Addendum to August 11, 2016 Application

315 S. Main Street Ann Arbor, Michigan

# Ann Arbor Historic Distric Commission

# *Summary of Proposed Changes Since the August 11, 2016 HDC Public Hearing:*

### 1. Cornice Profile at Level 3:

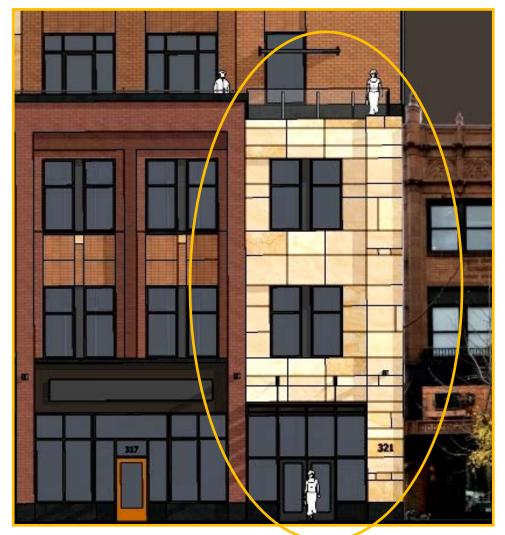
It was suggested that the cornice at Level 3 be re-designed to be visually stronger.

The detail shown below included a simple 6" black granite coping at the top of level three, center and north bays.

face brick below.

# The proposed revised detail is an approximate 16" stepped granit coping with a full soldier course of

### **3.** Window Sizes at Upper Levels:

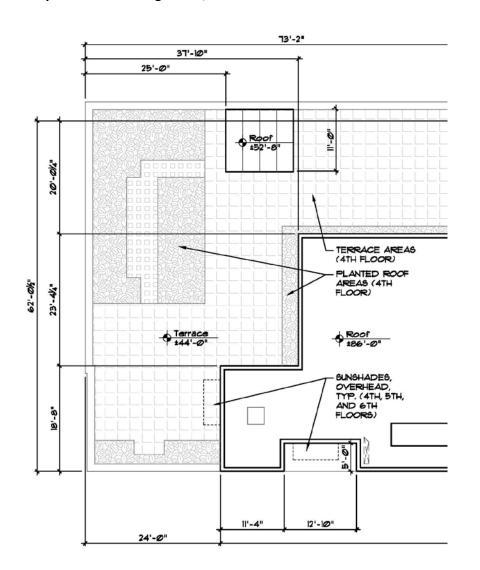
It was suggested that the floor-to-ceiling windows on levels 4, 5, and 6 emphasized verticality. Changing the window aspect ratio to square or horizontal might strengthen the horizontal lines of the upper levels

The window sills have been raised to two feet above the floors, resulting is a taller, more dominant, brick spandral panel between each window sill and the window head below. We have introduced a darker brick color to maintain visual alignment with contiguous architectural elements.

We have also introduced sun shades on the west facing windows of the central bay.

In addition, we changed the Mankato stone on the north bay of level 4 to face frick.

### 4. Setback of Terrace Level Activity:

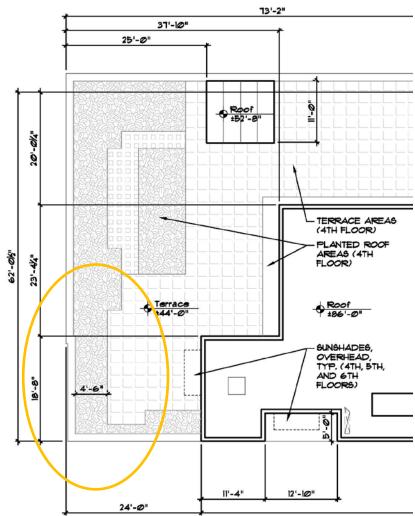
It was suggested that active use of a roof-top terrace might be undesirable and the design team was asked to expand the landscaped area of the 4<sup>th</sup> floor terrace in front of the railing at the west edge of the south bay.

### 5. South Elevation:

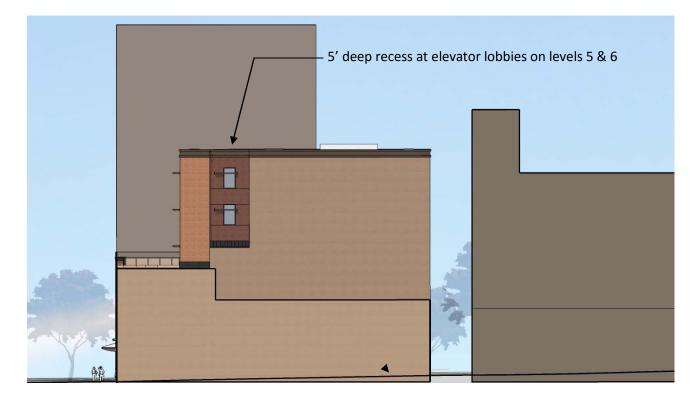
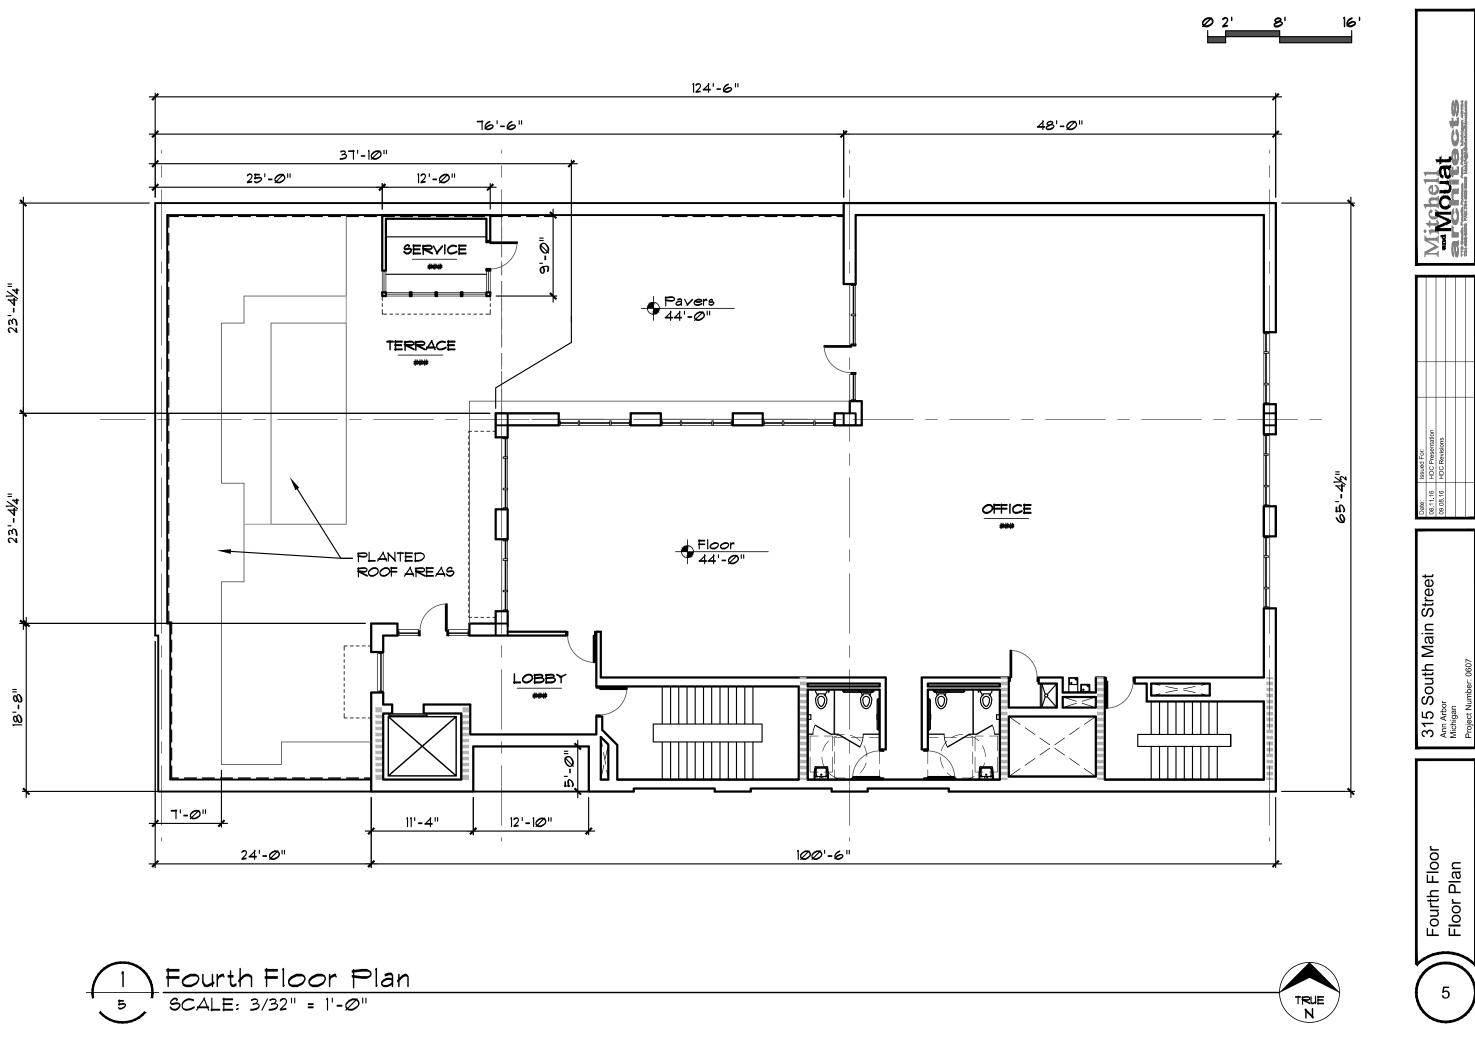
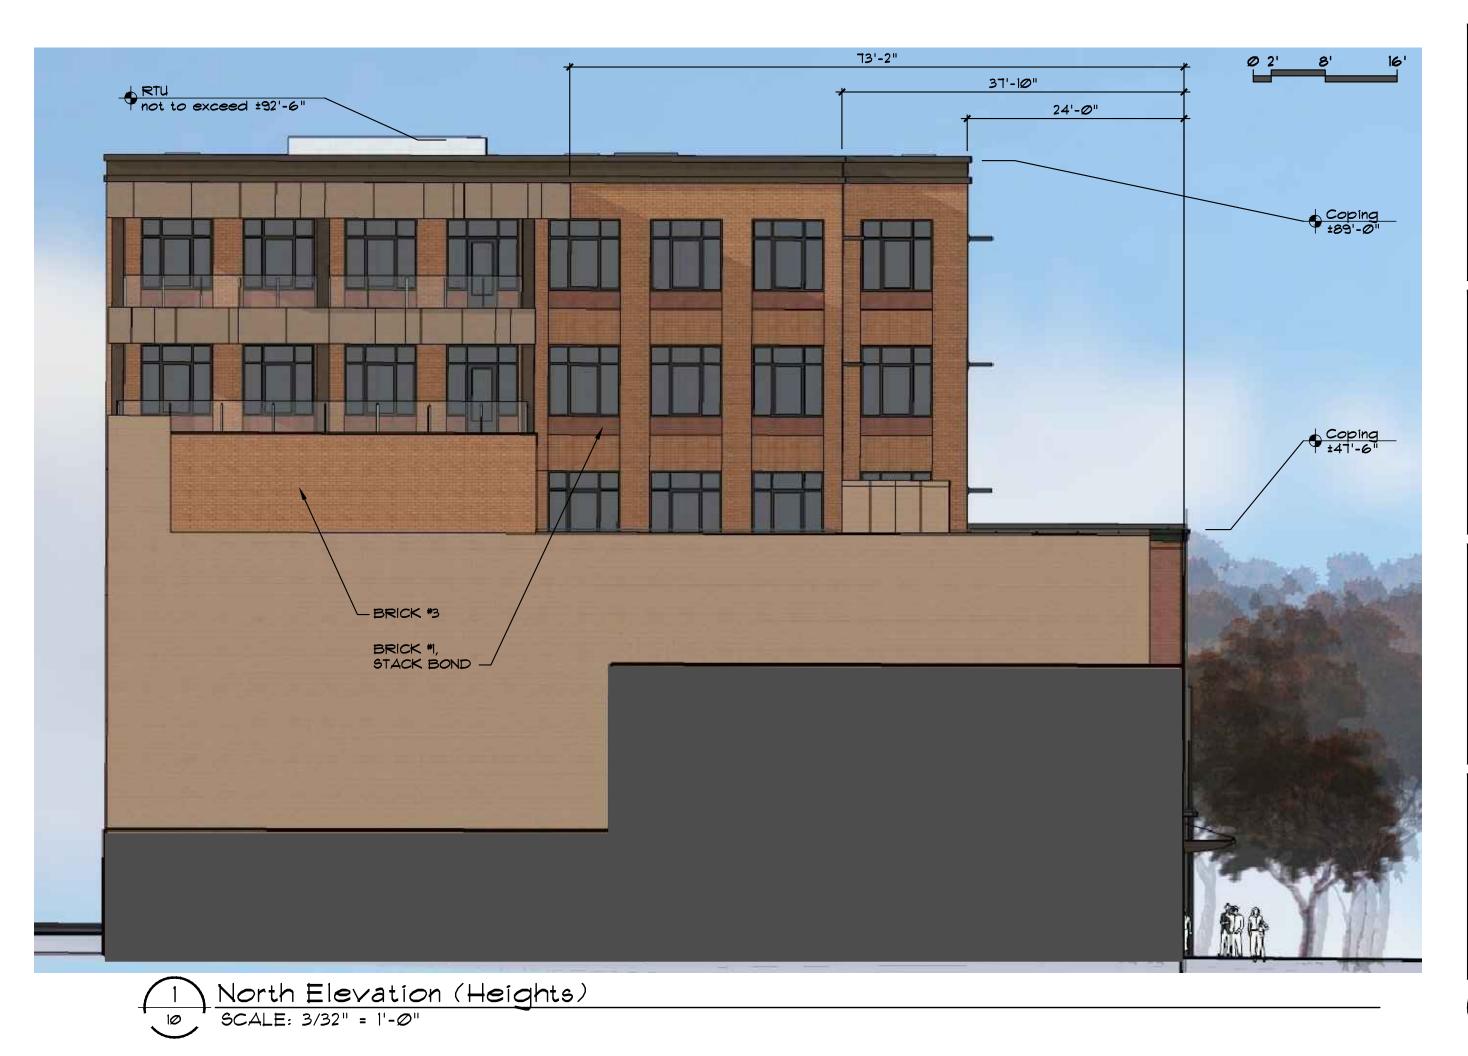
Commissioners generally favored the treatment of the west portion of the upper three south elevation floors, as shown below, due to the addition of a 5' deep recess at the elevator lobbies, offering visual relief to the party wall (this was an earlier suggestion by the HDC). It was suggested that a similar treatment be added to the east portion of the south wall.

Due to earlier advice from the HDC, we were able to create a 5' deep alcove with glazing is the elevator lobby on the  $5^{th}$  and  $6^{th}$  floors.

Knowing that current zoning in Ann Arbor allows for taller buildings outside the HDC District, to the south of the project site, and also knowing that south light can be severe and difficult to control in office settings, the design team placed all of the generally unoccupied building elements - including two enclosed egress stairs, an elevator, toilet rooms, and mechanical shafts - in the south bay of the building.

As discussed on August 11, openings in party walls (such as the south wall of 315 S. Main) are not allowed unless protected. However, on walls that are set 5' from party walls, up to 25% of the wall surface may be glazed.

Glazing and the setbacks that allow for glazing, were reserved for the north, west, and east exposures that provide the most beneficial daylighting for office use.

Opportunities for additional minimal 5' deep volume changes on the south elevation that respond to floor plan opportunities were sought, but none materialized.

The lower sketch to the left represents the proposed (revised) south elevation. We have included two rows of three approximatly 8' high X 11' wide recessed panels that align in height with the windows to the west. The surface of the panels are proposed to be placed 2" to 4" inside the main wall surface.

The recessed panels will be burnished or ground face block. The field of the wall will be split face block. The intent is to emphasize the horizontality with alignment of horizontal shadow lines.
